City of Portland, Maine – Building or Use Permit Application 389 Congress Street, 04101, Tel: (207) 874-8703, FAX: 874-8716

BUILDING PERMIT REPORT

DATE: November 2, 1995 ADDRESS: 135 Murray Street

REASON FOR PERMIT: To construct a 14' x 16' addition

PLOT PLAN SCALE 1" = 10'
 ANNE THERAULT 135 MURRAY ST PORTLAND

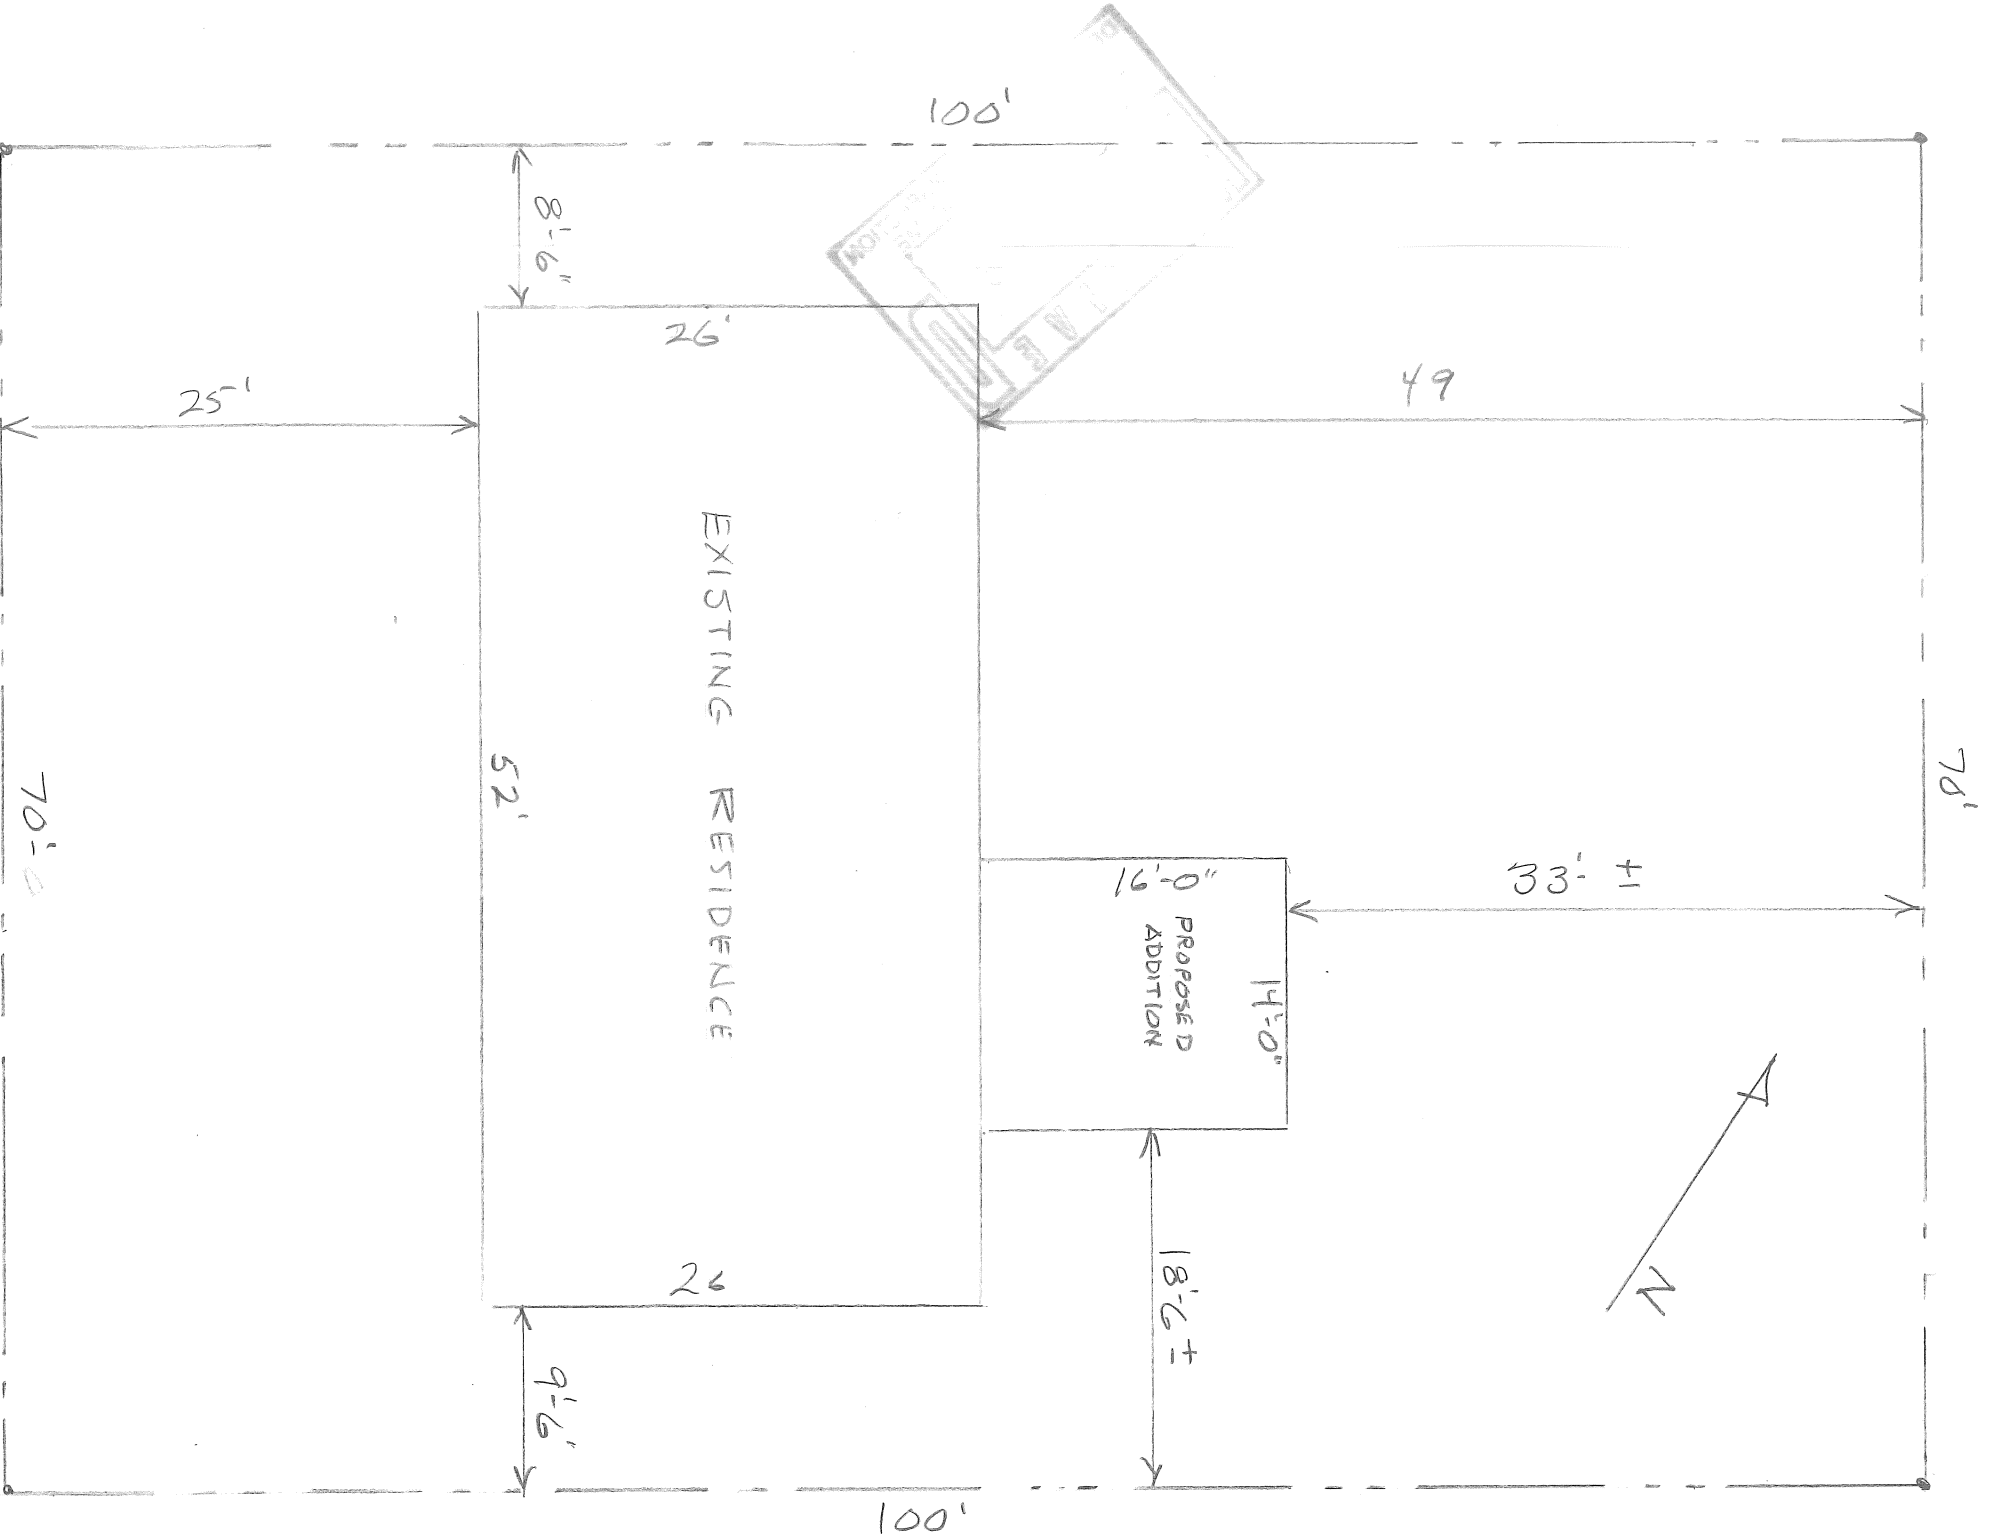
Use - 14' x 16' Addition (to remove 10' x 10' rear Addition)

Rear Yards - 25' req - 33' shown

Side Yards - 14' req - 10' 6" shown on lesser side

Building Area - MAX 25% of Lot Area = 1750# MAX
7,000# per assessors

condition
TO Remain a Single family?

1. This structure is to remain a single family dwelling.
2. Please read and implement items 1, 7, 9, 10, 11, 13, 14 and 15 of the attached Building Permit Report.
3. Please read and implement attached Section 2405./Safety Glazing, of the City's Building Code.
